**RE: Thomas Street Car Park (MP09-0066 MOD3)**

# COMMENTS ON THOMAS ST CARPARK CHATSWOOD DA APPLICATION,

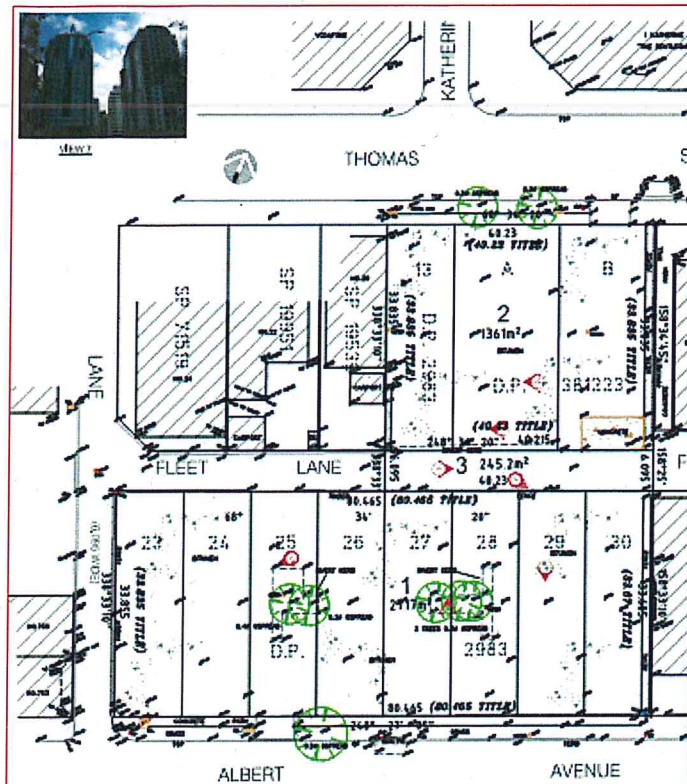
The inset picture shows a view up Katherine Street with Tower B on the left and Bentleigh residential flats on the right. Tower B is shown with a height of 189.95 metres.

The proposed Commercial Office tower is on an axis between Tower B and the view of the Sydney CBD (Harbour Bridge).

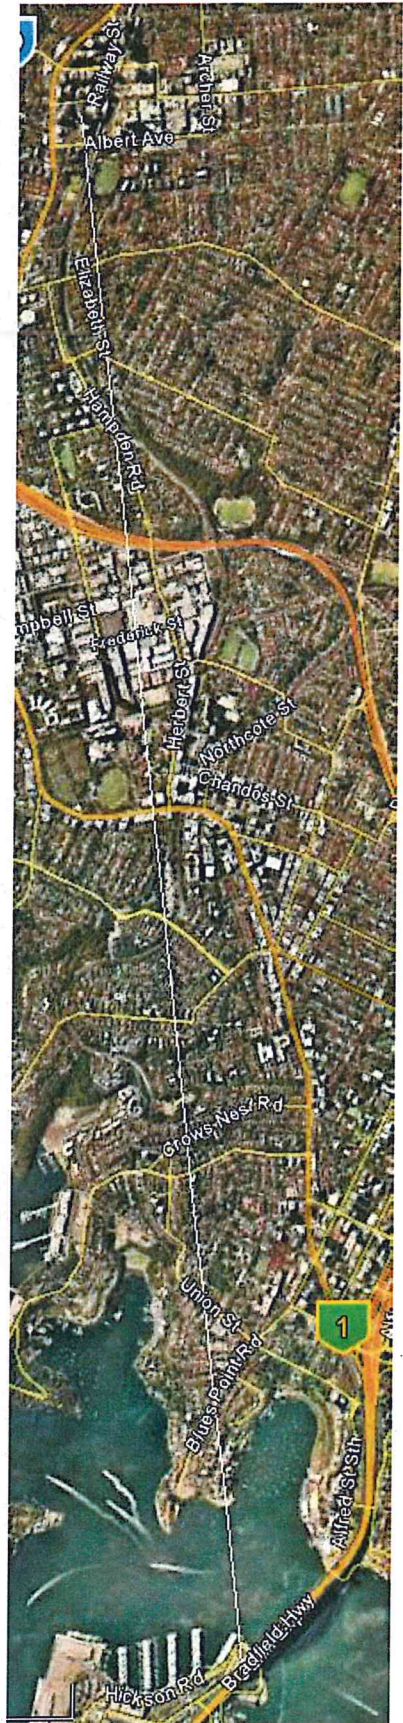
The proposed building's long axis is orientated East-West and will remove Tower B's CBD outlook that has been a feature of the office space for over 20 years.

Tower A will be similarly compromised.
